Addendum 05

PROJECT: Fort Loramie Local Schools Athletic Complex Building & Associated Improvements
600 East Park Street
Fort Loramie, Ohio 45845

PROJECT #: 25041.00

This addendum form is a part of the Contract Documents and modifies the Bidding Documents dated December 11, 2025 with amendments and additions noted below.

SHEET NUMBER:
E4.1

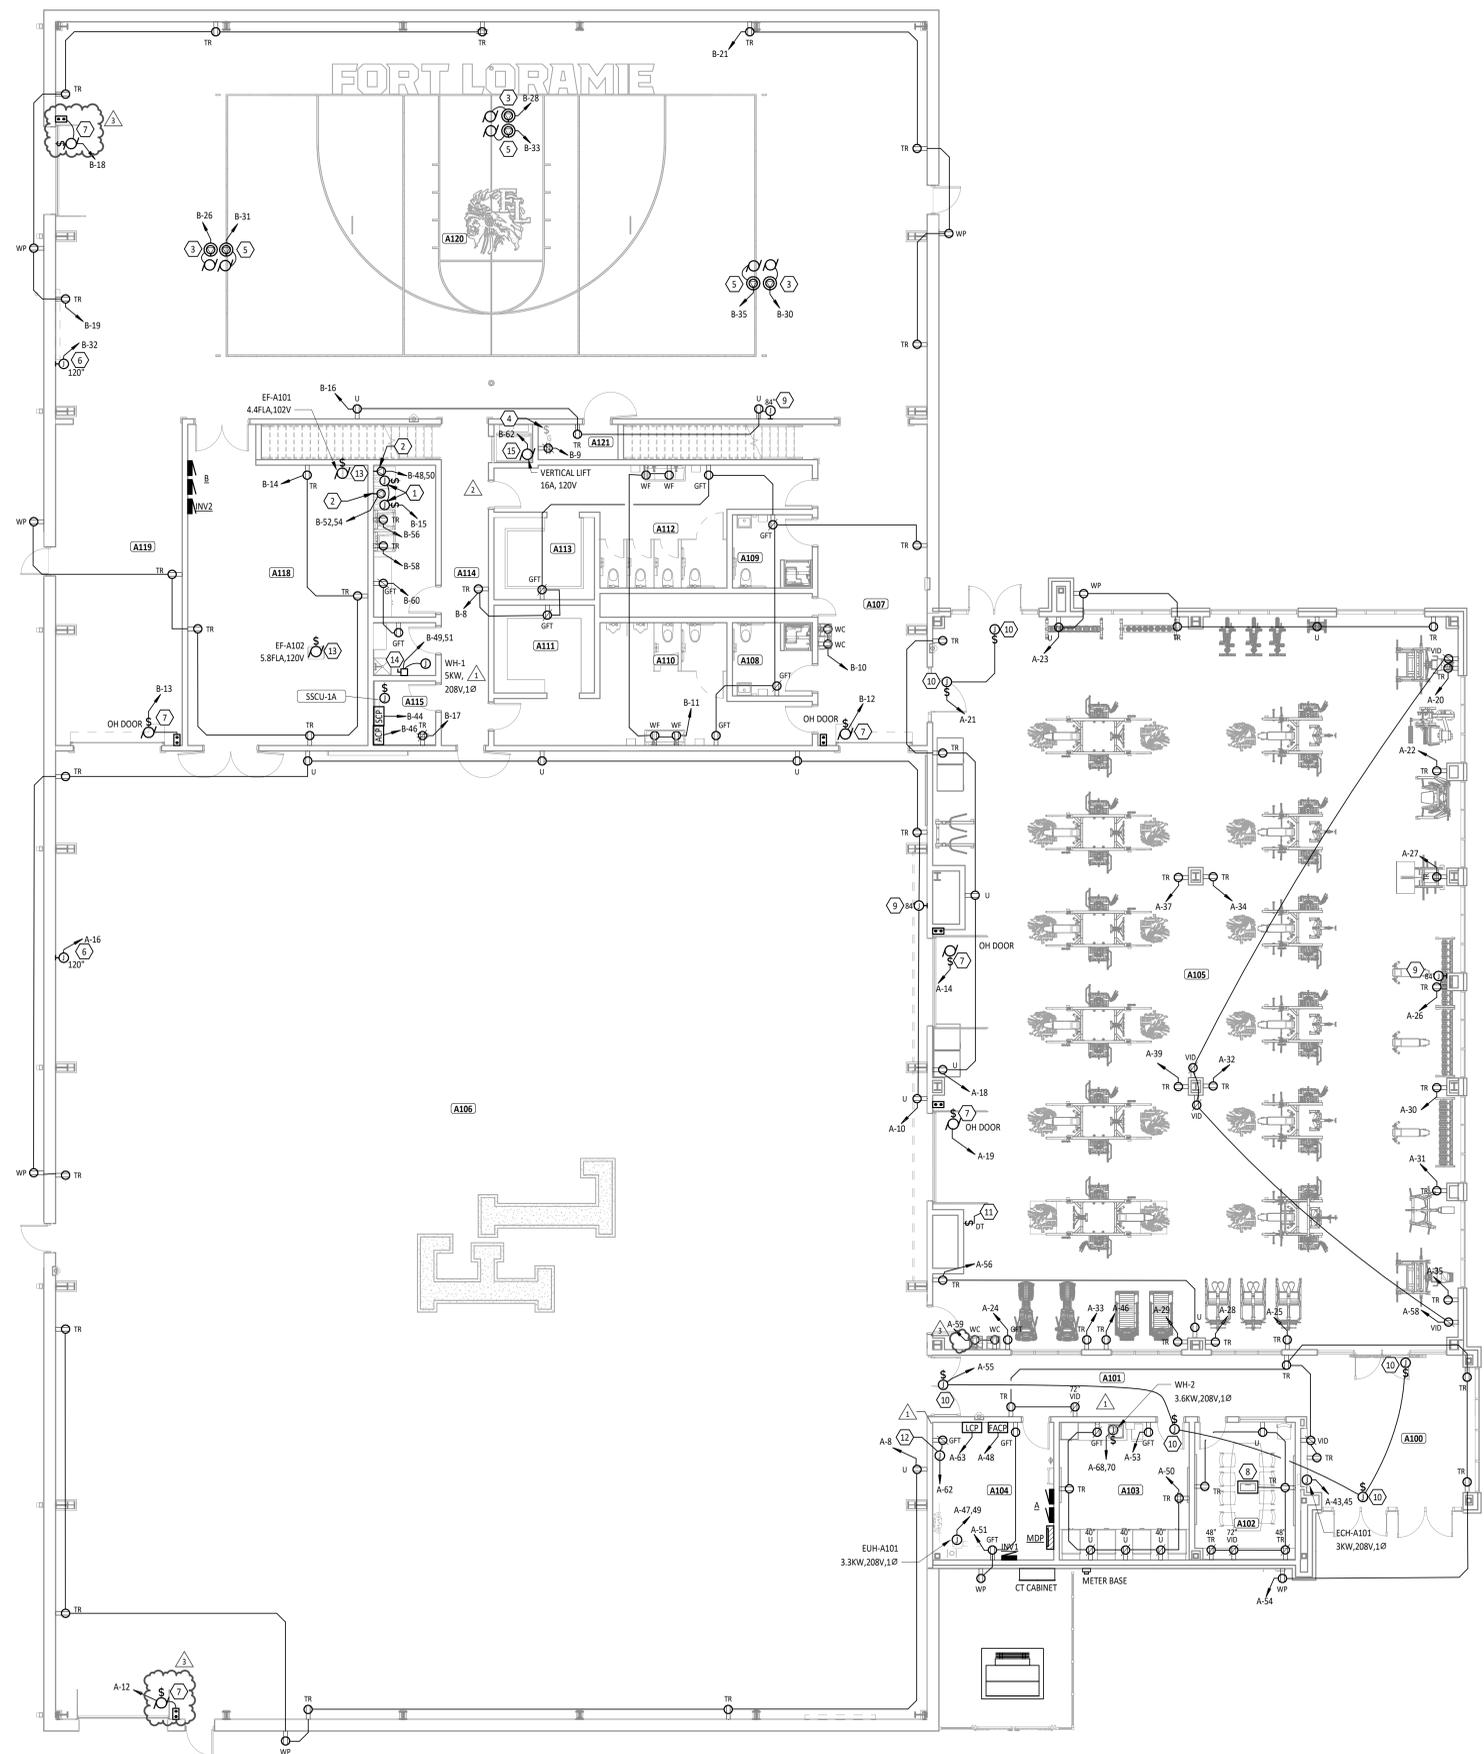
16. Sheet E4.1 – First Floor Lighting Plan
 - a. Removed exit sign from A107 (not a path of egress).
 - b. Added exit sign in A107 (correct path of egress).

- c. Removed exit sign in A120 (not a path of egress).
 - d. Added 2 exit signs in A114.
17. Sheet E5.1 – First Floor Power Plan
 - a. Removed dead face GFCI (already protected by GFCI circuit breaker in A105).

1 ELECTRICAL ONE-LINE DIAGRAM
NO SCALE

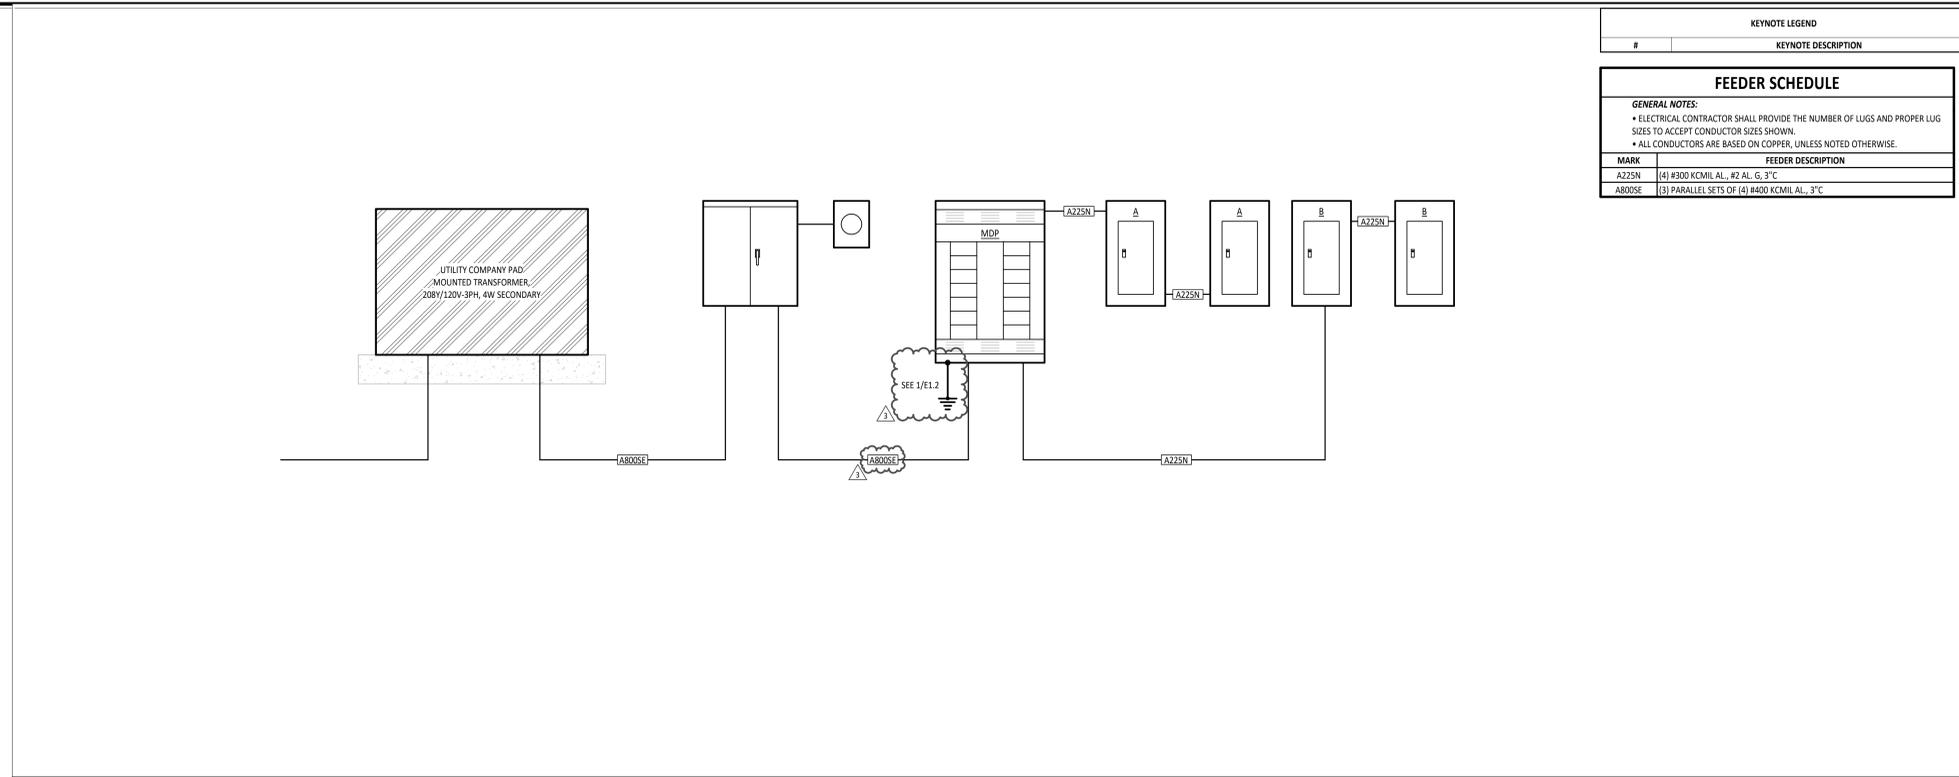
19. Sheet E8.1 – Electrical One-Line Diagram and Panel Schedules
 - a. Panel B (2 of 2) - Provided GFCI circuit breaker for clothes dryers.
 - b. One-line - Added a grounding annotation to the MDP.

SHEET NUMBER:
T1.3

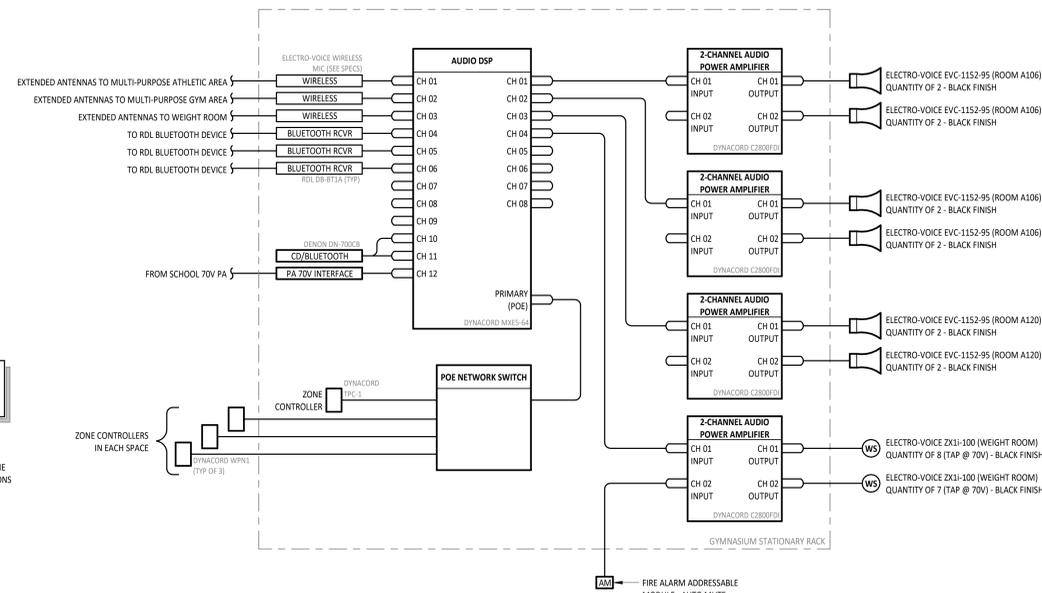
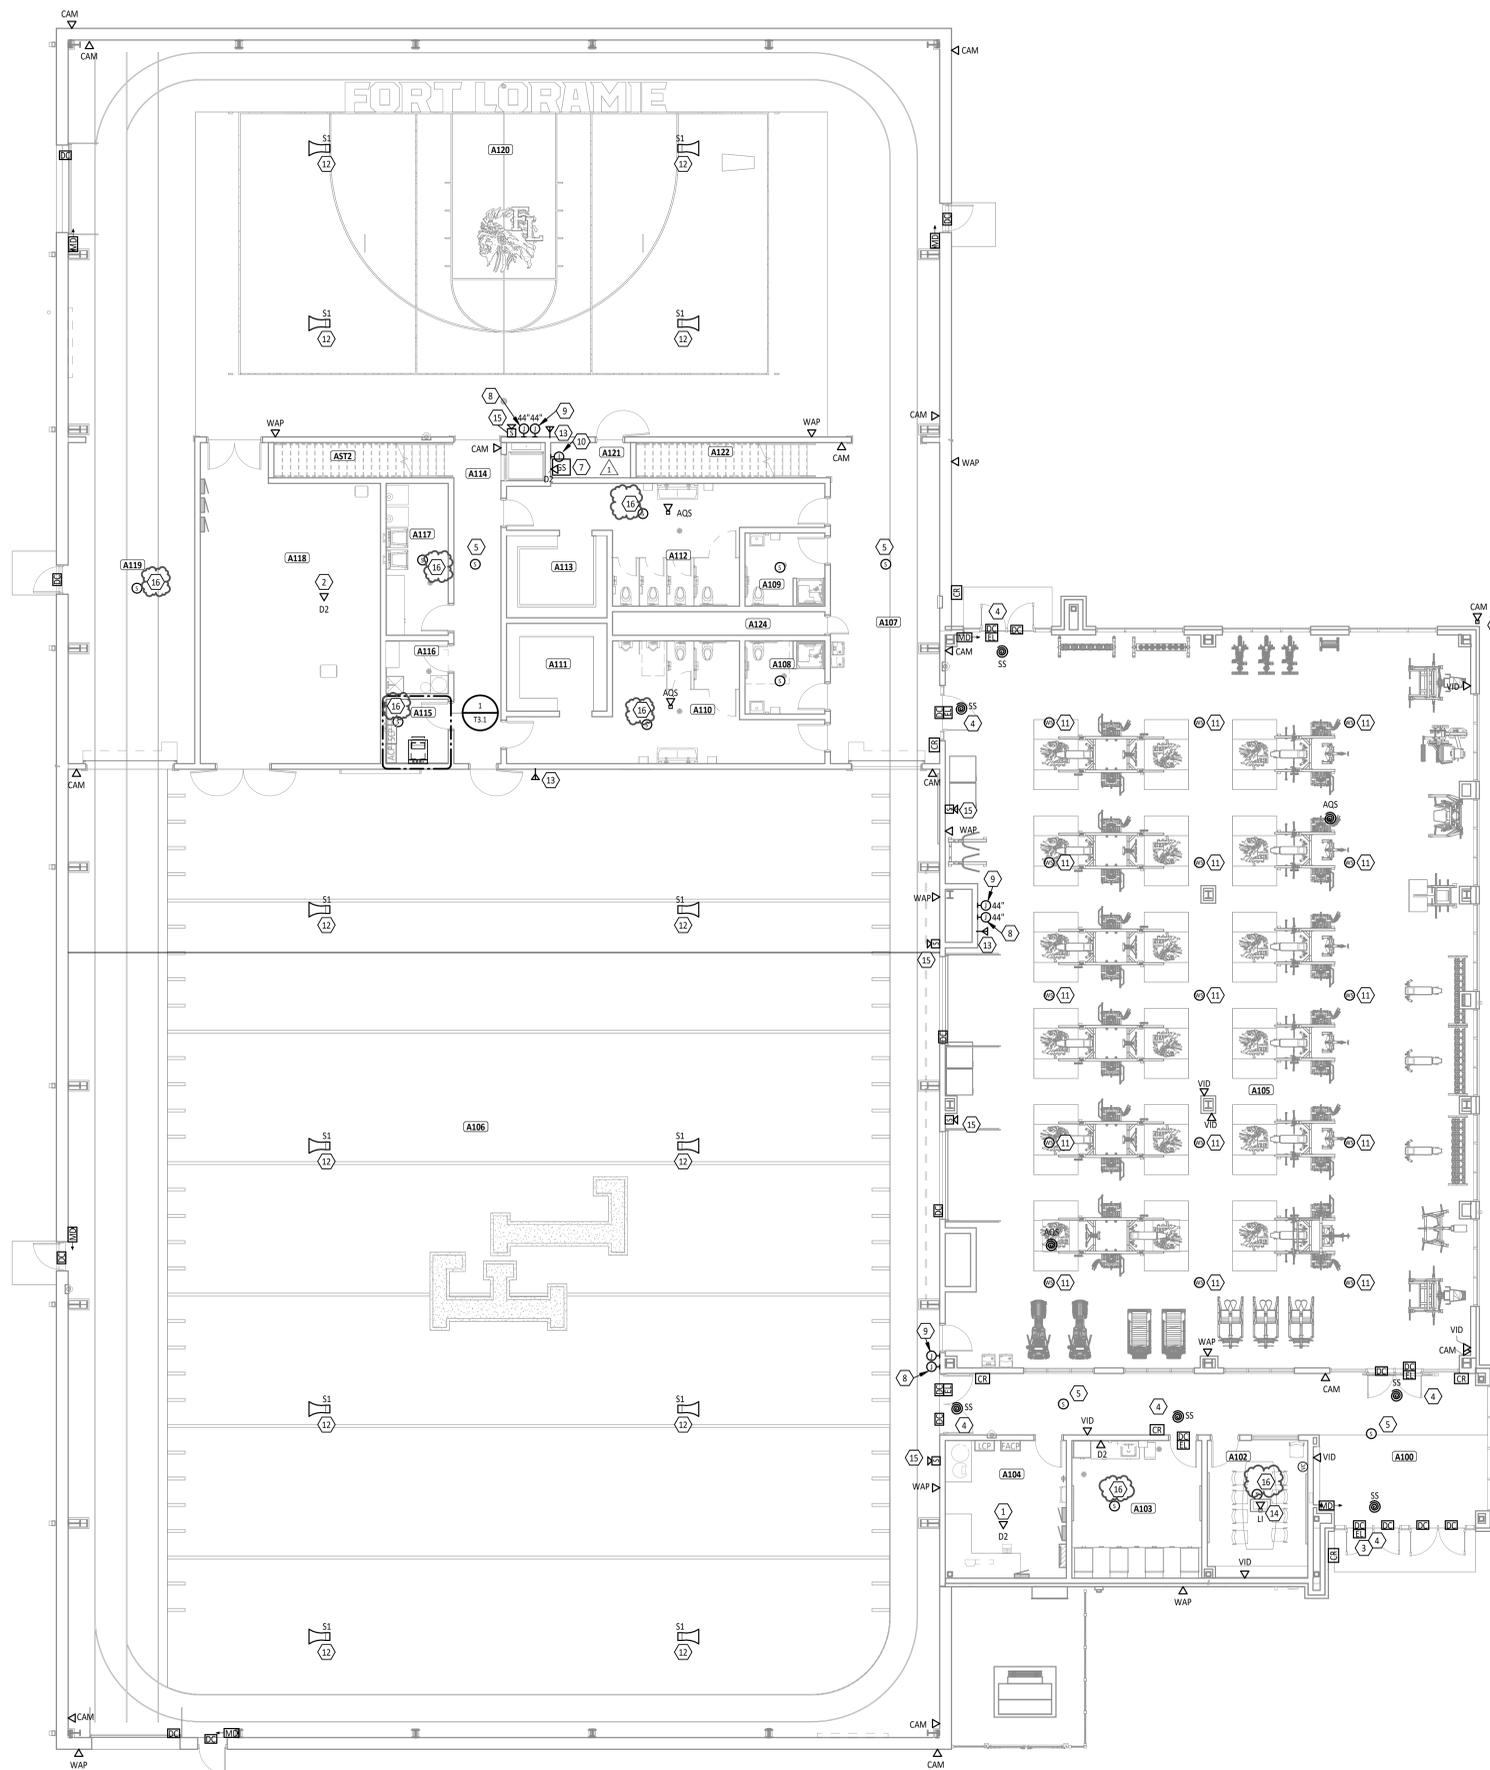
- 20. Sheet T1.3 – Technology Details
 - a. Changed cable type from Cat6 to Cat6a
- 21. Sheet TC1.1 – First Floor Technology Cabling Plan
 - a. Additional keynote to clarify speaker types

5. Faceplate details indicate using Cat 6A cabling except for the "LI" and "LVP" detail. those two are calling for Cat 6. Please clarify.
 - a. **Response: Cat6a cabling is required. Sheet T1.3 has been updated and included with Addendum 05.**
